**Rocky Mountain Arsenal
(Operable Unit 16), CO**

**FINAL DECISION DOCUMENT
FOR THE INTERIM RESPONSE ACTION
AT THE
M-1 SETTLING BASINS
ROCKY MOUNTAIN ARSENAL
MARCH 1990
CONTRACT NO. DAAA15-88-D-0022/0002
VERSION 4.0**

RESPONSE TO COMMENTS FROM THE EPA
ON THE PROPOSED DECISION DOCUMENT
FOR THE M-1 SETTLING BASINS
NOVEMBER 1989

Figure 2-2

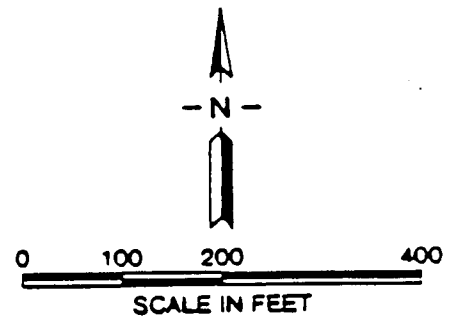
Comment 1: The groundwater elevation has been estimated on Figure 2-2, yet the saturated thickness of alluvium with seasonal variations, which affects several alternative actions, is not discussed.

Response: The text has been revised to discuss this point (Section 2.0). Figure 2-2 has been revised. The groundwater elevations have been removed since they are not relevant to the location map.
